RE: Marion County
CR 42 At SE 182nd Ave. Rd. Intersection Improvements
FPN.: 434844-1-58-01
FAN: D522-073-B
Contract No.: G2M09
Change Order No. 02

Change Order #02 Entitlement Analysis

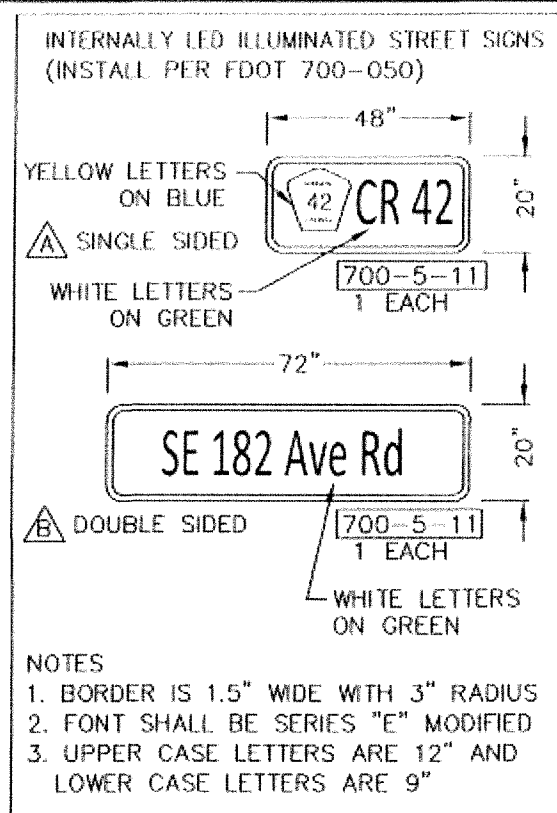
Can you issue a RFI regarding the illuminated signs for this project? It appears that the design shown on the plans was for aluminum signs not illuminated signs. Please see the comments from our signal equipment vendor and ask the EOR how they want us to proceed. He has attached two drawings to show the difference.

If we build the proper signs it appears they will have to be bigger which will also mean that the pole mounted brackets will have to be bigger as well, which will increase our pricing.

See the spec above. As you can see on the proof, I used the same spec that was provided above.

Used a 1.5" Border with 3" Radius.

Used series E Mod Font.

Used 12" upper case and 9" lower case lettering.

Also, in the layout above, the signs are blade signs. The layout does not take into account that there is a frame that needs to go around the sign.

Please see the attached preliminary drawing. To get the signs down to the size that was requested, I had to use the following specs.

Use .80" border with 1.5" radius

Use Series D font.

Use 8" upper case letter and 6" lower case letter.

The Marion County logo will need to be sized down to an 8x8" square in order to fit in the provided space.

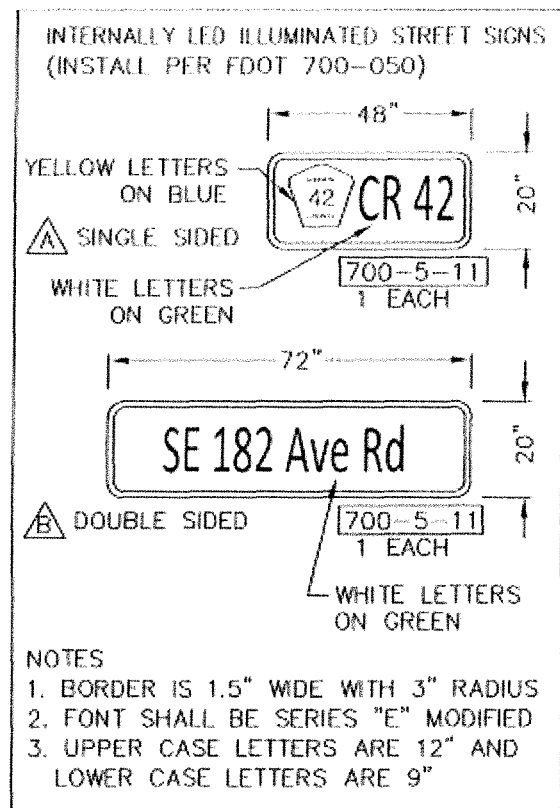
See the spec above. As you can see on the proof, I used the same spec that was provided above.

Used a 1.5" Border with 3" Radius.

Used series E Mod Font.

Used 12" upper case and 9" lower case lettering.

Also, in the layout above, the signs are blade signs. The layout does not take into account that there is a frame that needs to go around the sign.

Please see the attached preliminary drawing. To get the signs down to the size that was requested, I had to use the following specs.

Use .80" border with 1.5" radius

Use Series D font.

Use 8" upper case letter and 6" lower case letter.

The Marion County logo will need to be sized down to an 8x8" square in order to fit in the provided space.

The plans called for internally illuminated signs, which is what we want installed. I'm ok with increasing the size of the signs if it's needed to fit the text.

The illuminated sign designs that Temple provided need to be revised per the comments below. Some of these comments were included in the signals submittal that we sent back for revisions.

- Letter height shown in upper right corner is 10". Revise to correct height for each sign.
- Sign B (single-sided) will not use an underhang mount. It will be rigidly attached to the cantilever arm.

- Remove the Marion County route sign logo.
- Change "CR 42" to "SE Hwy 42". This is the street name assigned by 911.

- Use "Av" instead of "Ave" for the abbreviation.
- The sign cannot exceed 9 ft per FDM 230.2.10. If needed, use E Mod font with 10" uppercase and 8" lowercase.
